PALO VERDE NUCLEAR GENERATING STATION

NUREG-0612 section 2.1 general requirements for overhead handling systems

ARIZONA PUBLIC SERVICE COMPANY
PROJECT MANAGER AND OPERATING AGENT

Docket # 50-528
Control # 8106300462
Date 6-25-81 of Document
REGULATORY DOCKET FILE

FUEL BUILDING CRANE
TRAVEL LIMITS
Figure 9.1-2

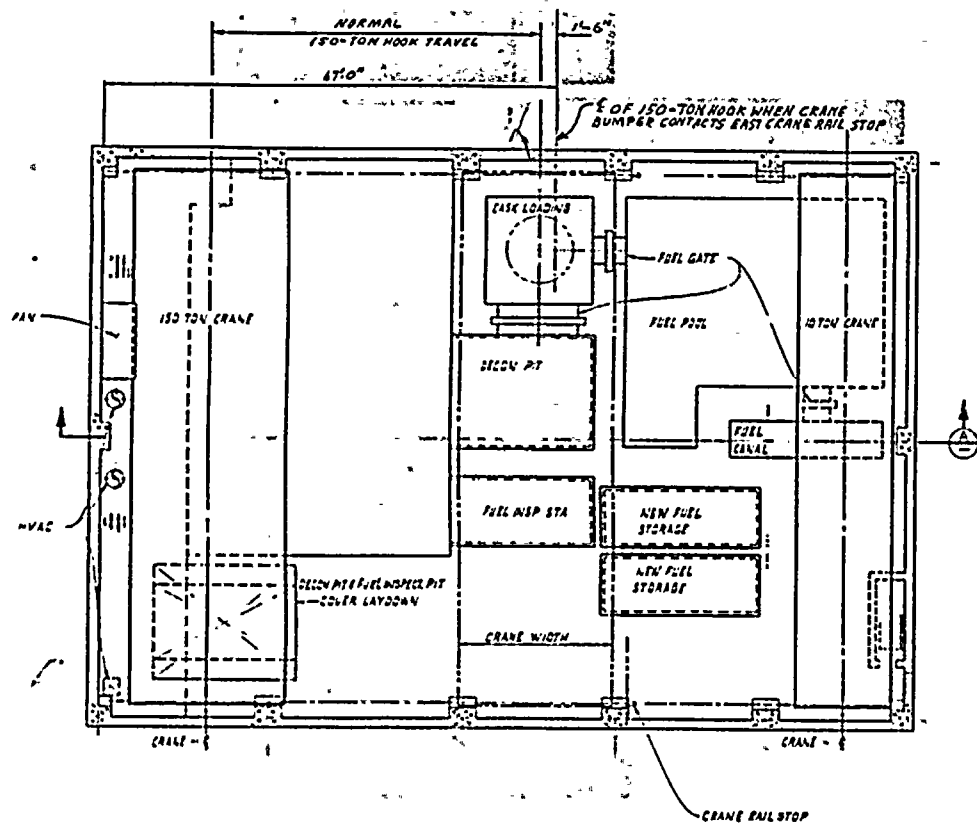
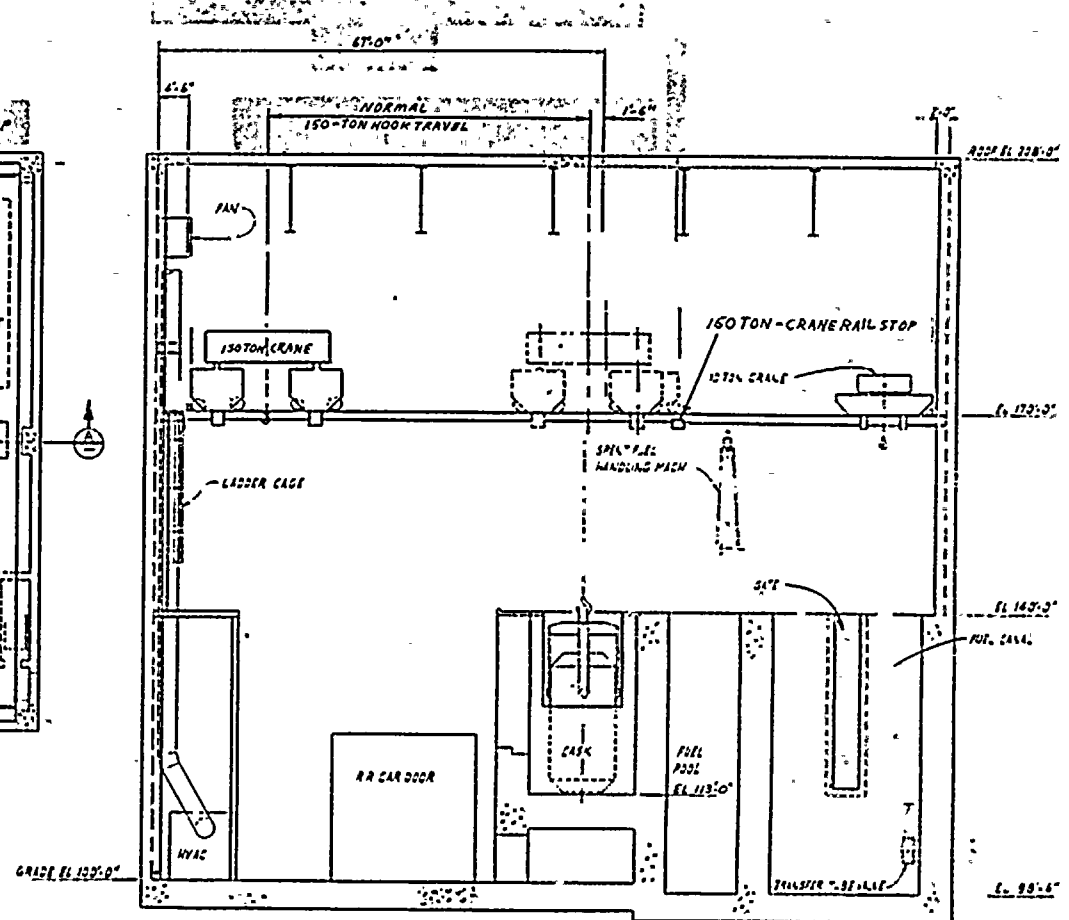
- C A safe load path has been established and is incorporated in our design specification. Refer to Exhibit F-1 and F-2.
- D Refer to Exhibit F-1. Safe load paths have not been established but will be developed per section 5.1.1 NUREG-0612 before fuel load, November, 1982. They will be incorporated into the PVNGS Equipment Maintainability Data Manual and they will be shown on equipment location drawings as safe load paths.

PVNGS Evaluation: Except for the cask handling crane (Exhibit F-1 AND F-2), safe load paths have not been developed for overhead heavy-load handling systems listed under 2.1.3a herein. Safe load paths will be established per the guidelines of NUREG-0612 section 5.1.1(1) and incorporated into our procedures per the guidelines of NUREG-0612 section 5.1.1(2) prior to the handling of heavy loads.
